PROJECT REVIEW

1. CASE 21.094, 163 PROSPECT STREET, House, post 1926 (COLLEGE HILL)

Project: Three Family Residence
Address: 163 Prospect Street, Providence, RI 02906
Date: 24 August 2021
Re: Application Information

5 WINDOW SCHEDULE - PROPOSED
A1.1 1/4" = 1'-0"

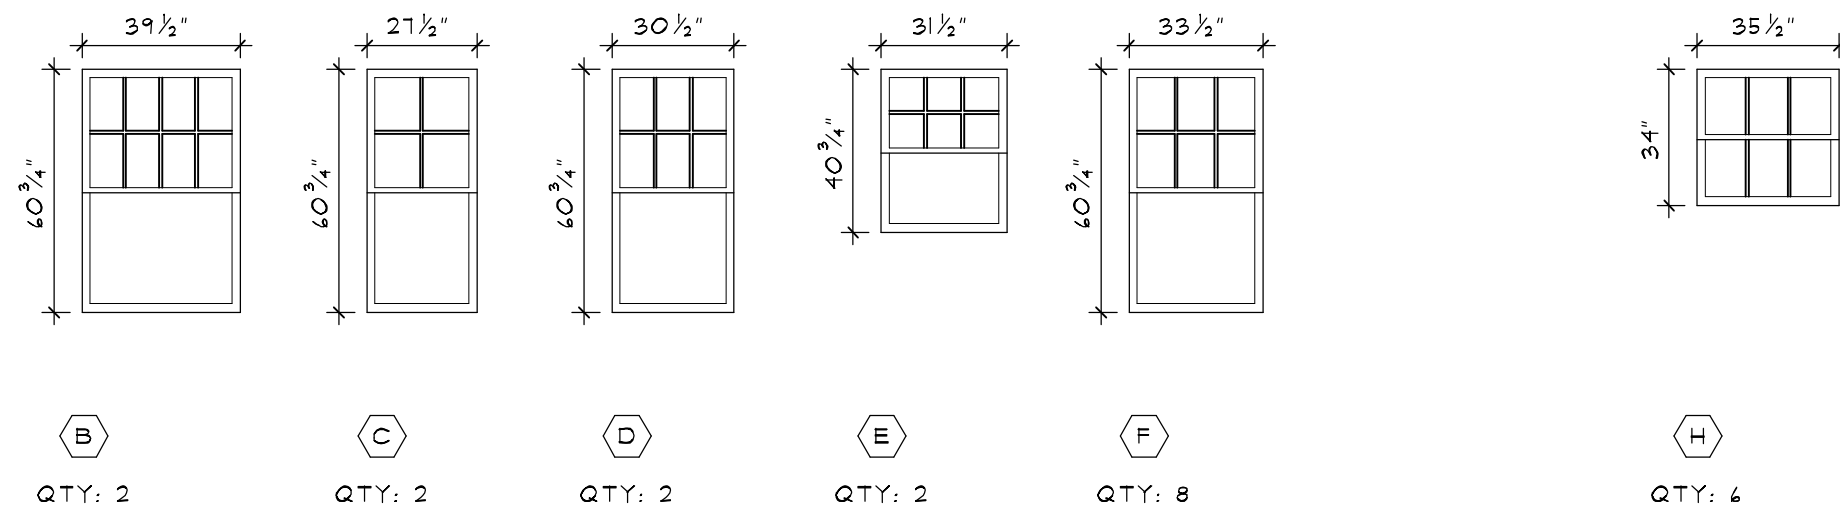
- Sash Replacement: The units to be replaced are twenty-two (22) units in the ground and first floor. On the attached window schedule, they are units B, C, D, E, F & H. We propose to replace the window sashes in their current sizes and configuration.

The new double hung sashes shall be Trimline Ultra Fit (Classic Clad) sash replacement kit. These are wood units, insulated glazing with aluminum clad exterior and vinyl jamb liners. Muntins to be simulated divided light. Exterior color to be earth tone (chocolate brown). New window screens to be half-window. The existing sashes and aluminum storm windows shall be removed.

Staff recommends a motion be made stating that: The application is considered complete. 163 Prospect Street is a structure of historical and architectural significance that contribute to the significance of the College Hill local historic district, having been recognized as a contributing structure to the College Hill National Historic Landmarks District. The Commission grants Final Approval of the proposal as submitted having determined that the proposed alterations are appropriate as the proposed alterations are architecturally and historically compatible with the property and district having an appropriate size, scale and form that while diminishing the historic quality of the property will not have an adverse effect on the property or district and allows the property to come into compliance with RIGL § 42-128.1-8, citing and agreeing to the recommendations in the staff report, with staff to review any additional required details.

2
A2.1
PROPOSED SASH REPLACEMENT
1" = 1'-0"

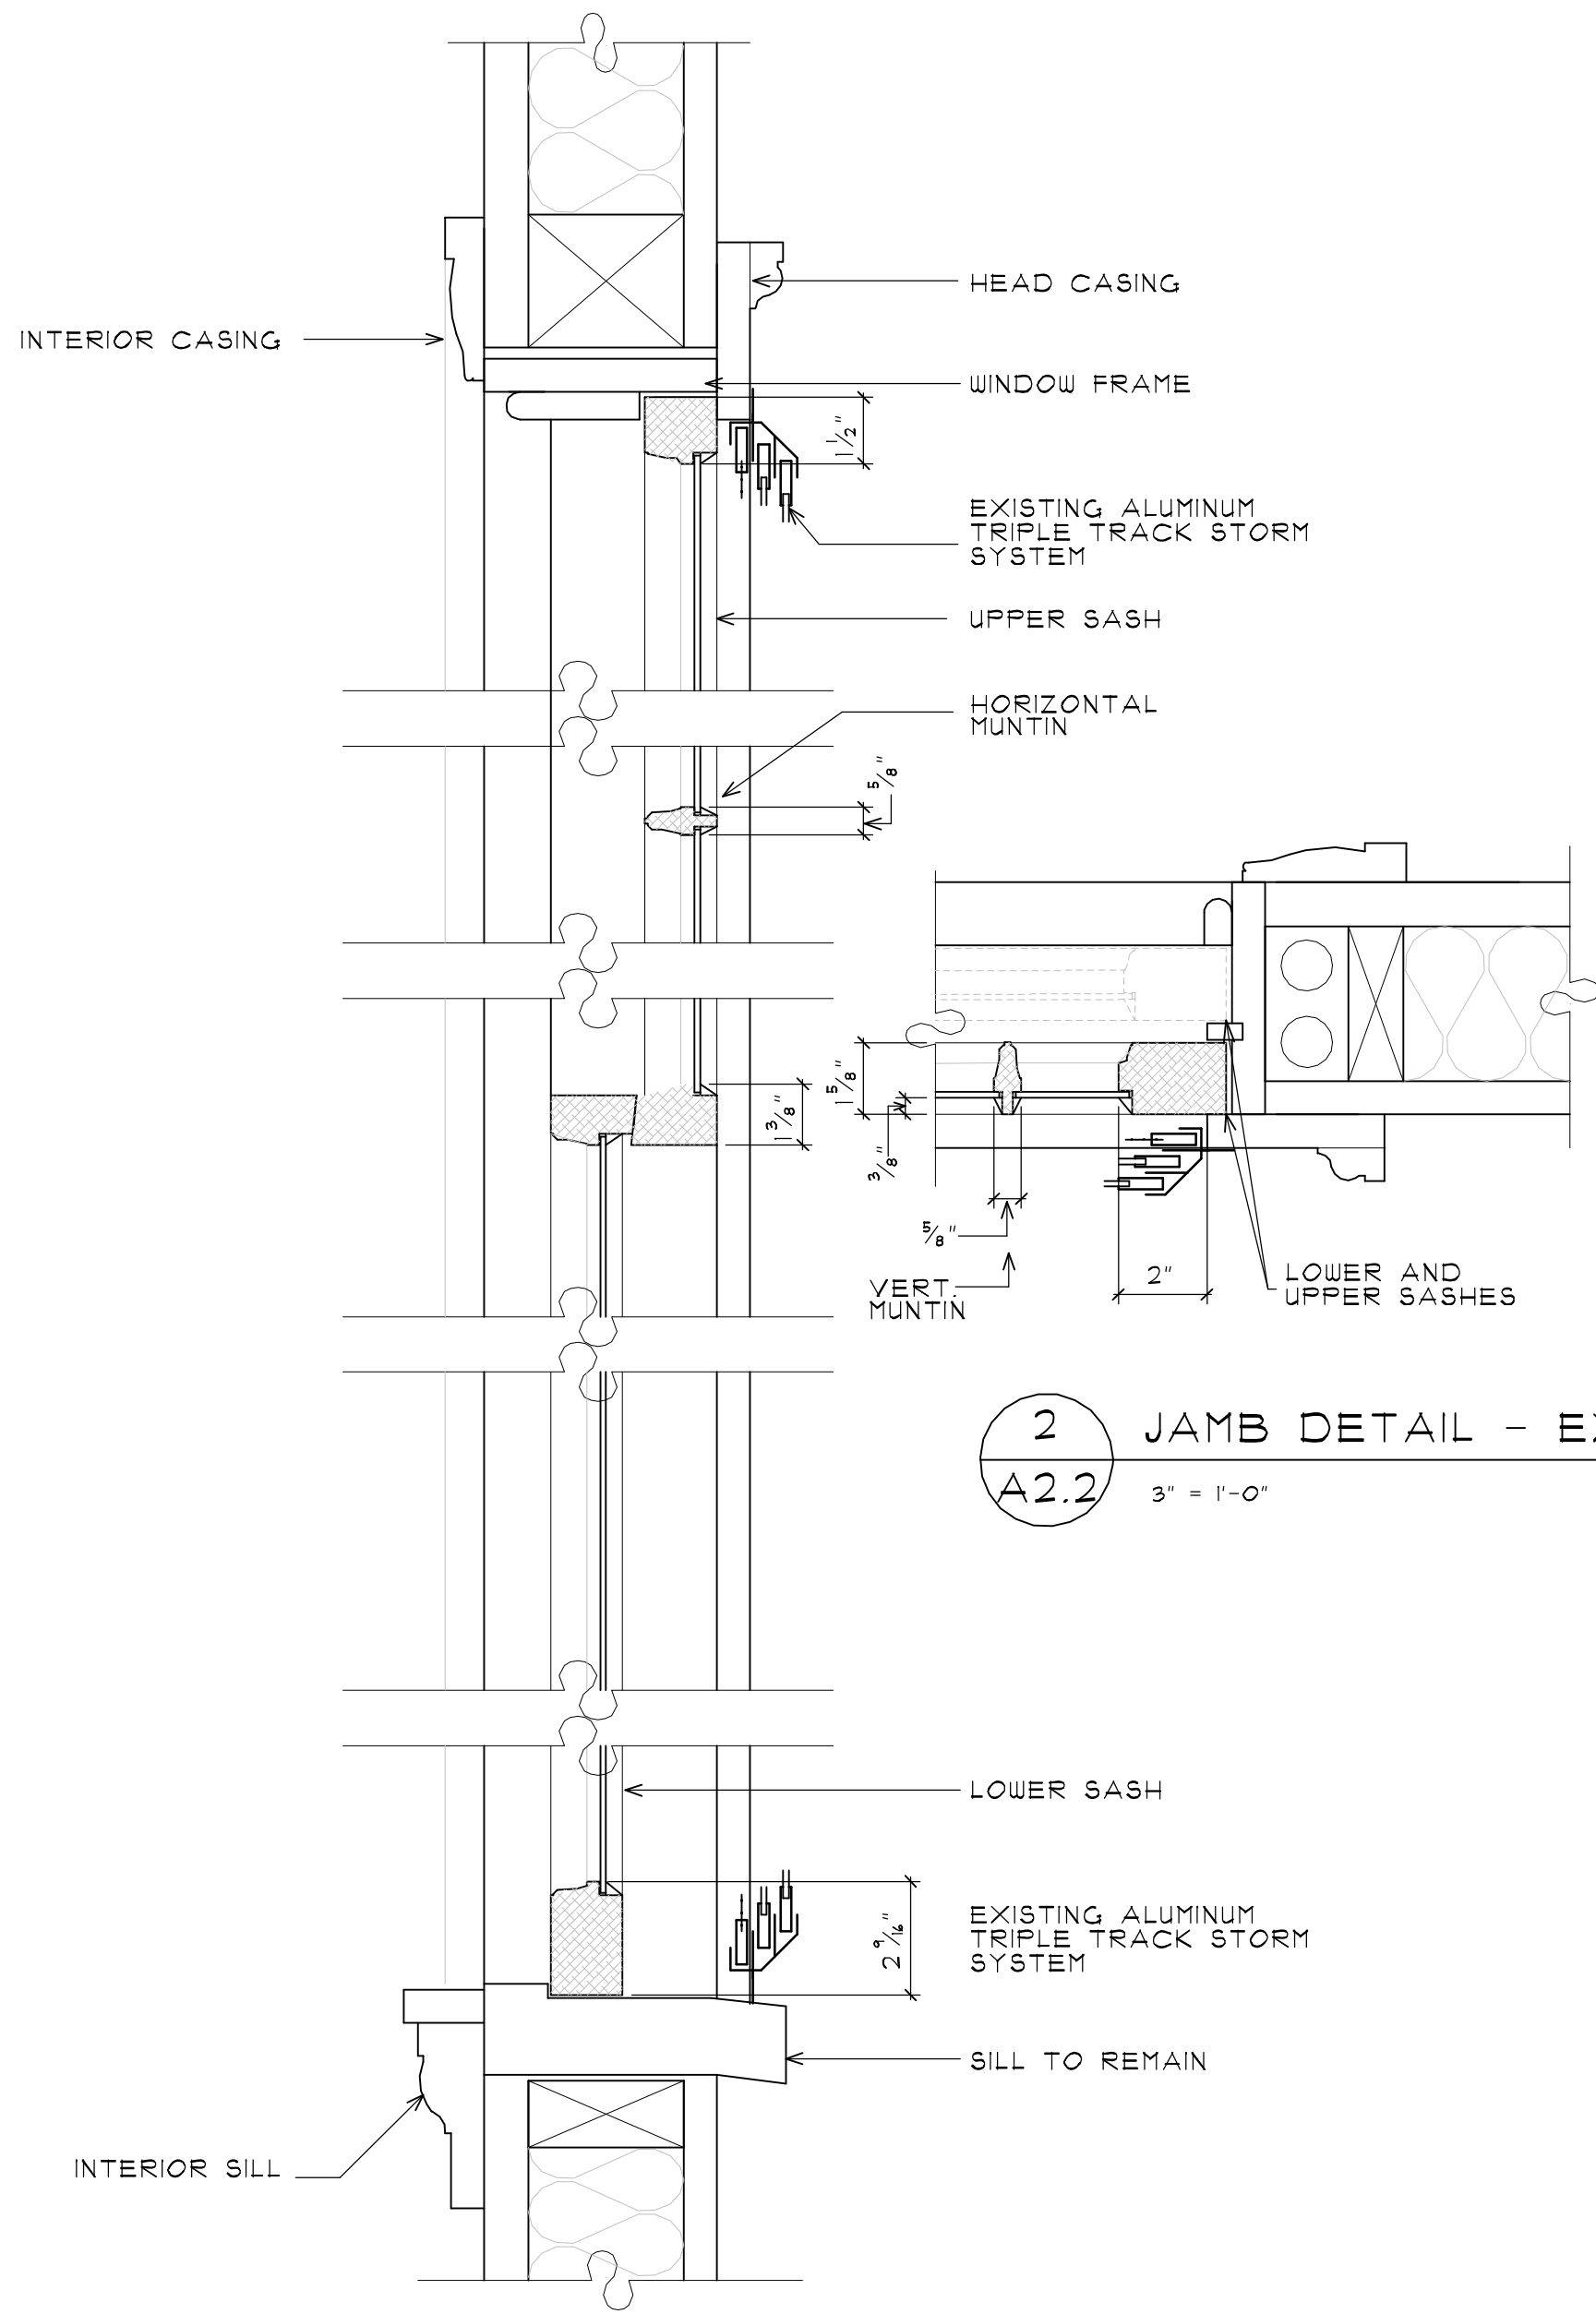
be matched. The difference in glass area reduction is 3% for unit "F". From the exterior, the new sashes, along with removal of the storm windows, will result in windows which are close to the original in size, function, appearance and profile depth with windows within the wall plane, which is diminished by the storm windows.
